SOLICITATION, OFFER, AND AWARD (Construction, Alteration, or Repair)	1. SOLICITATION NO. VA101-14-R-0074	2. TYPE OF SOLICITATION <input type="checkbox"/> SEALED BID (IFB) <input checked="" type="checkbox"/> NEGOTIATED (RFP)	3. DATE ISSUED	PAGE OF PAGES 01 85

The contractor shall provide all labor, materials, transportation, supervision, supplies and tools necessary to completely prepare site for building operations, including demolition and removal of existing structures, and furnish labor and materials and perform work for the construction of up to 6,860 columbarium niches, new administration building and public information center, repairs to existing roadways, replacement of existing signage and site furnishings, landscaping, irrigation, and site utilities as required by drawings and specifications. Project includes a series of add alternates including renovation of the existing maintenance building, construction of a memorial wall, columbarium cap replacement, additional road repairs, and additional 5,536 columbarium niches.

Project location: National Memorial Cemetery of the Pacific (NMCP), 2177 Puowaina Drive, Honolulu, Hawaii 96813

NMCP
VA101-14-R-0074
Amendment #2
March 2

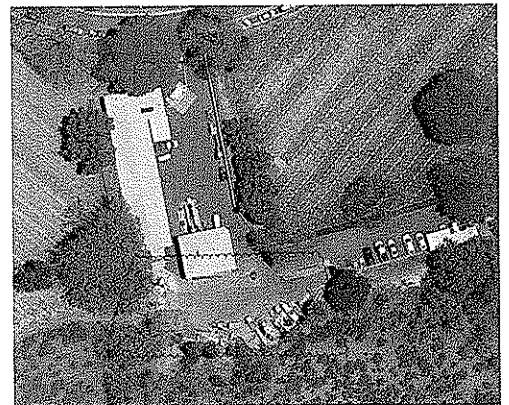
26. Also in the same specification section 2.19 f says exposed faces shall have smooth finish unless otherwise noted. I cannot find anything in the plans or specifications that indicates any type of stain to be applies or colored concrete to be used. Am I correct in assuming that these will be a natural concrete color?

Response: Yes
